JOYFUL VIEW SUBDIVISION

A PART OF THE SOUTHWEST QUARTER OF SECTION 33,
TOWNSHIP 13 SOUTH, RANGE 63 WEST OF THE 6TH P.M.
EL PASO COUNTY, COLORADO

Final plat drawings V1 PCD STAFF CCombined.pdf Markup Summary 11-2-2022

JOYFUL PLAT.DWG
SEPTEMBER 26, 2022
PROJECT 21048
SHEET 2 OF 2

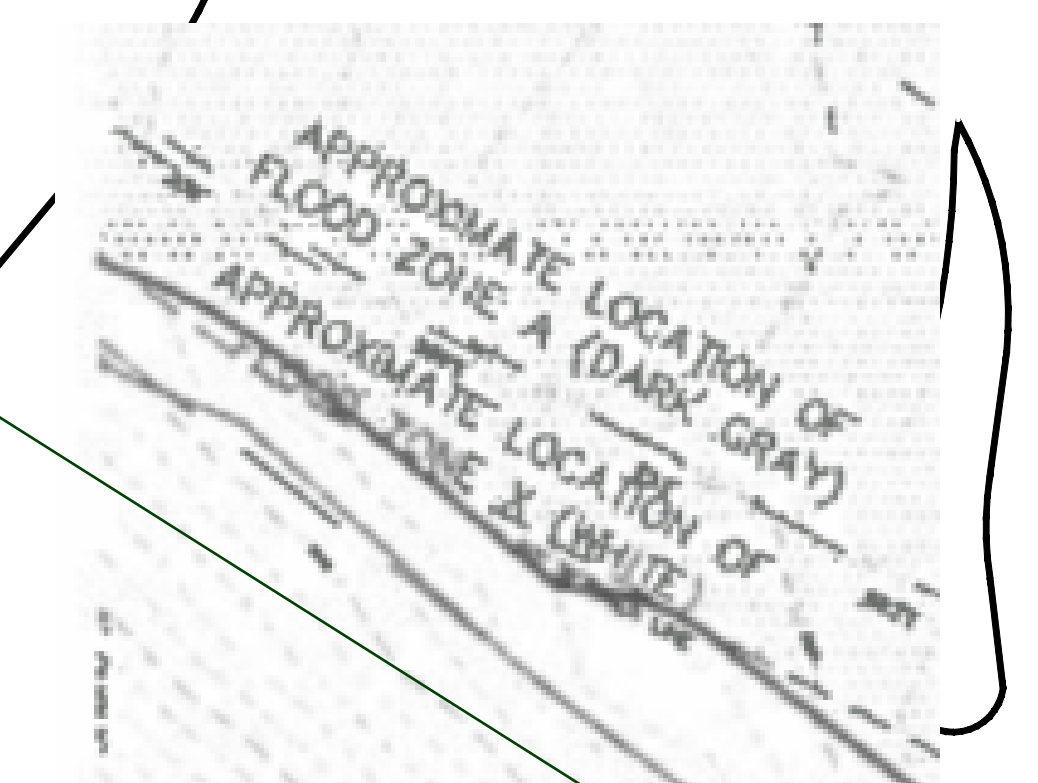
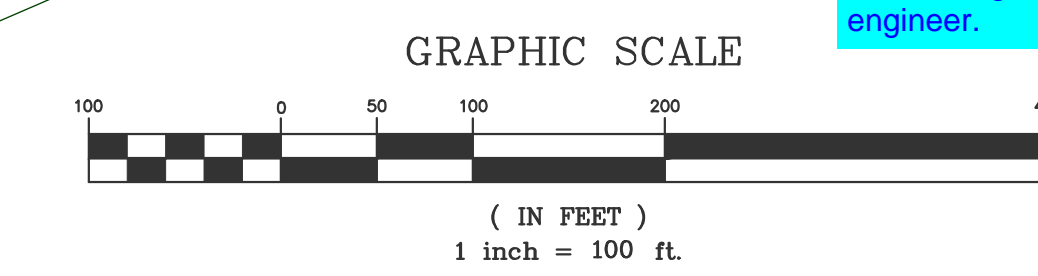
Add required turn around point per FD comments. See note no plat about turn around point beyond floodplain which may not be needed since the road does not continue

Correct with parcel #

Update Road name

Show correct property parcel lines to the north

This is not correct adjacent per LSP Rec #208900290

Errant line

add TSN # of all adjoining parcels around the property

Add road classification

Provide easement Rec # for northern 30ft of pvt road. Land Survey Rec #205900168 drawing only mentions 30ft not 60ft or provide shared access agreement

Correct with TSN

Add temp Cul-de-sac and easement per ECM 2.3.8. Address this temp turnaround pt in Plat notes

A Engineer approved site plan will be required for lots 7,8,9 due to 30ft utility and drainage easement. Add to plat notes. Correct all drawings on GEC, DR, plat to show consistent lot #s.

CD, DR & GEC plans are showing a 30ft utility and drainage easement. Show recorded or planned drainage and utility easements on all effected lots

Both Floodzone X and A are present

Add Base Flood Elevations (BFE)

Please confer with FD about the turn around at this point. They thought the road continued when just the easements are shown. A cul-de-sac is not needed if the road does not continue past the floodplain. Per PHONCON with FD #221025

provide additional easement to accommodate the proposed ditch at the cul-de-sac.

Add road classification and name

Denote a no build setback line along floodplain boundary

Geo report indicates missing labels for easements

is this meant to describe the dashed line below? 20'

Provide drainage easement for swale/channel at this lot. Coordinate with the drainage engineer.

GEO Notes should reflect the drainage, and the no build area for specific lots; Lots t; Growenwater should be noted (review GEO report and customize the note)
